**Subject: NEXTERA BLYTHE SOLAR ENERGY CENTER LLC'S RESPONSE TO
CEC STAFF DATA REQUEST SET 1 (1-19)
BLYTHE SOLAR POWER PROJECT AMENDMENT
DOCKET NO. (09-AFC-6C)**

BLYTHE SOLAR POWER PROJECT (09-AFC-6C)

RESPONSES TO DATA REQUESTS – SET 1

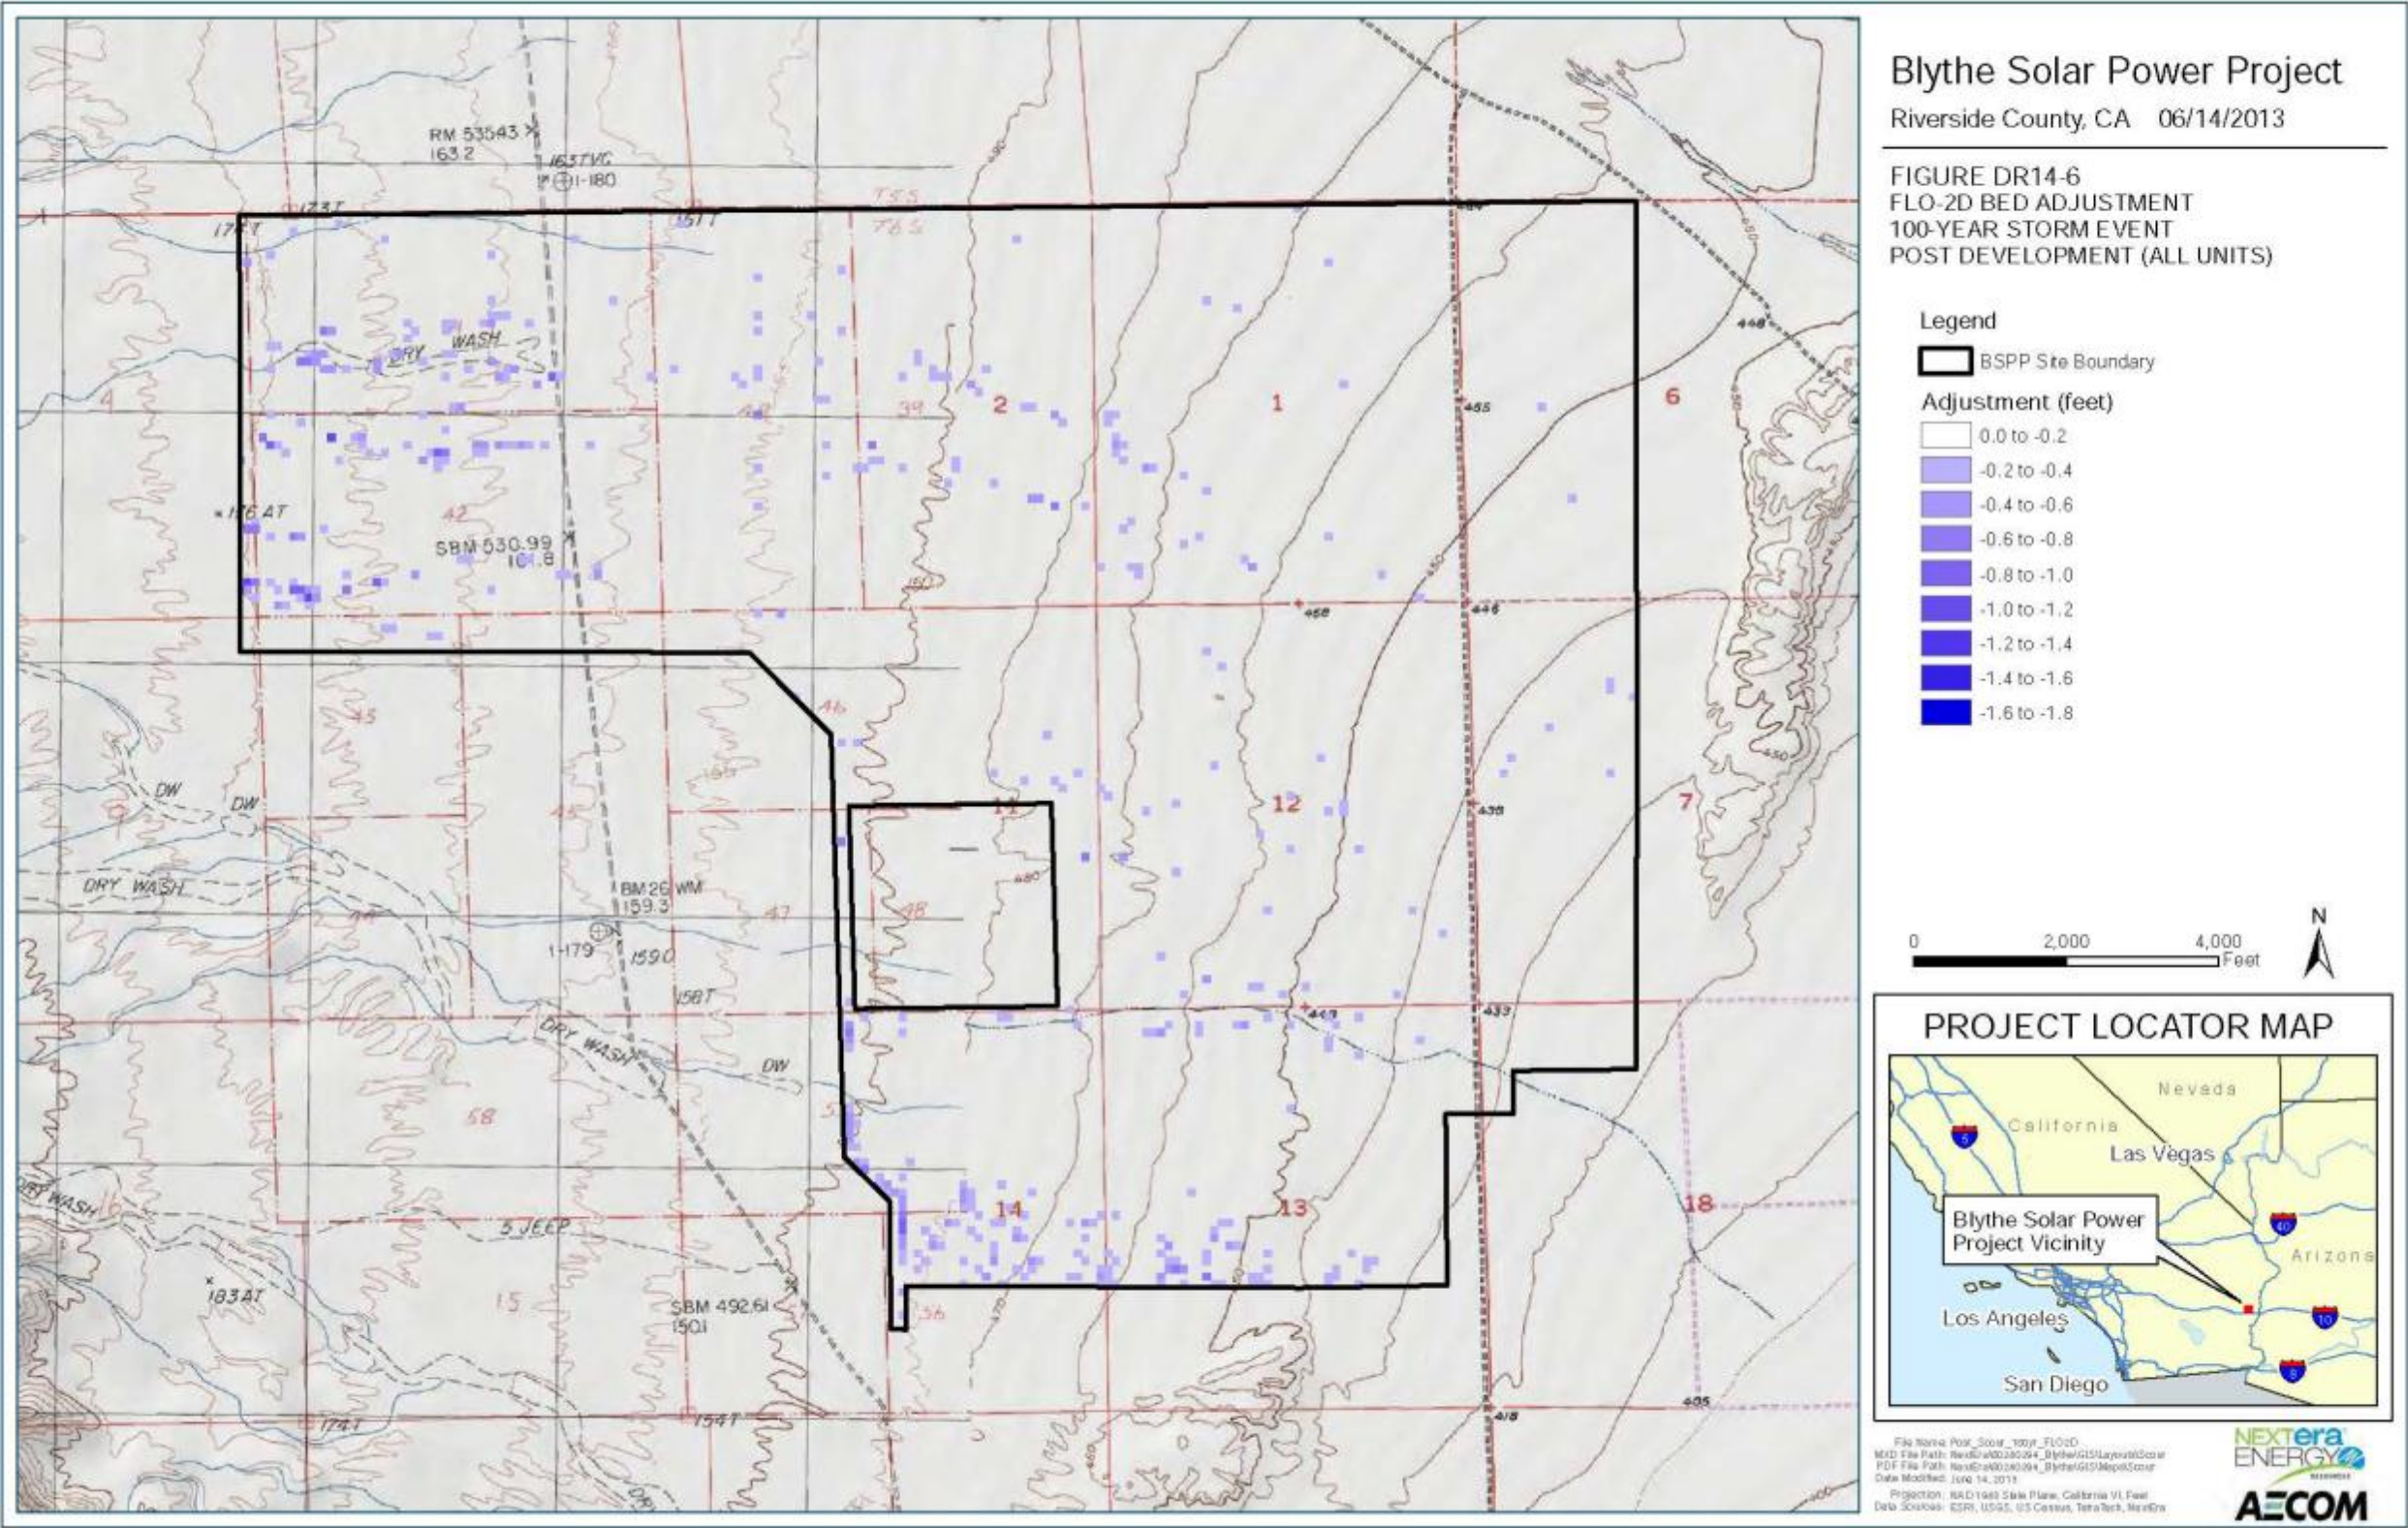
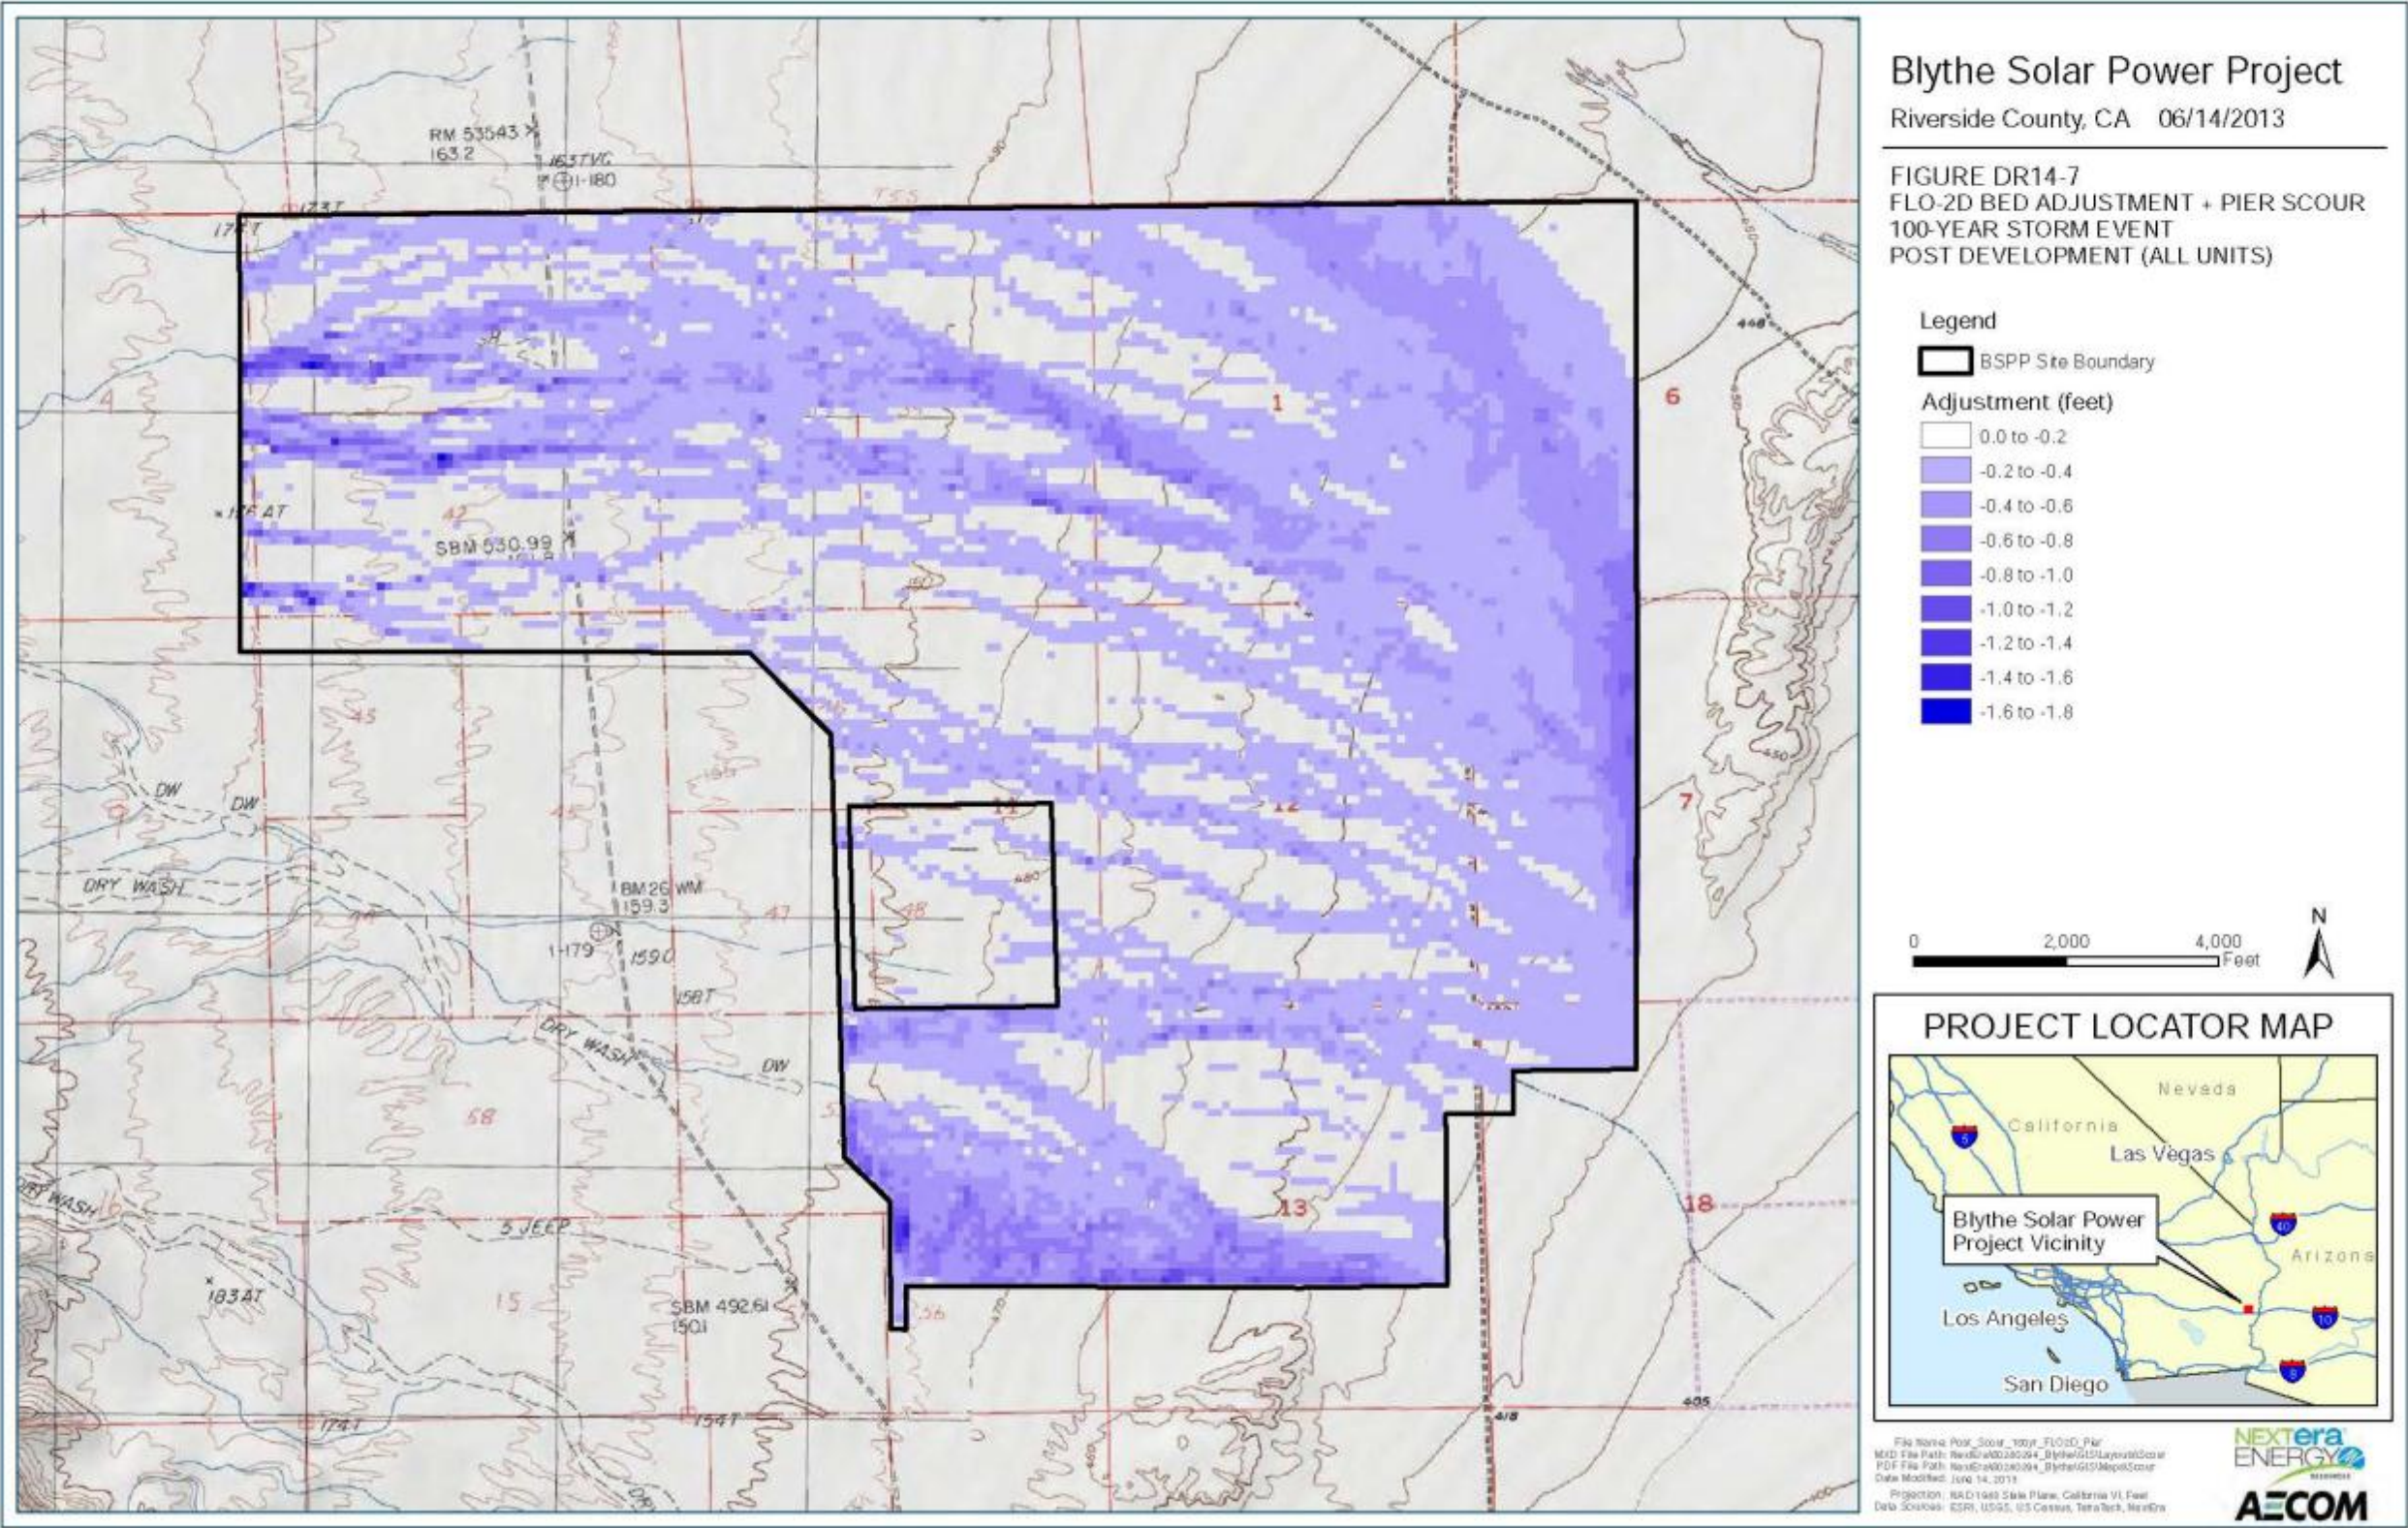
14. Please provide an analysis showing how much scour might be expected along panel foundations in the washes.

The result of the general adjustment analysis is shown in Figure DR14-3. The figure shows that the general adjustment ranges from 0.00 to 0.12 feet of degradation during the 100-year, 24-hour event. The results of the analyses for pier scour and total adjustment are shown in Figure DR14-4 and DR14-5, respectively. The analysis indicates that pier scour is expected to range from 0.03 to 1.47 feet over the project site for the 100-year, 24-hour event. The total scour (general adjustment plus pier scour) is expected to range from 0.03 to approximately 1.57 feet over the project site during the 100-year, 24-hour event when based on the LACDPW SM method.

The FLO-2D model was run to simulate the sediment transport associated with the 100-year, 24-hour precipitation event. The bed adjustment values resulting from the simulation are shown in Figure DR14-6. The FLO-2D model results indicate bed adjustment (degradation only) ranging from 0.00 to 1.20 feet within the project site. The FLO-2D method shows a slightly greater general bed adjustment than the general adjustment for the SM method. Figure DR14-7 shows the bed adjustment resulting from the sum of the FLO-2D and pier scour analyses (using the same pier scour values calculated using Neill's method). The combined FLO-2D bed adjustment and pier scour indicates that the total scour is expected to range from 0.03 to 1.64 feet.
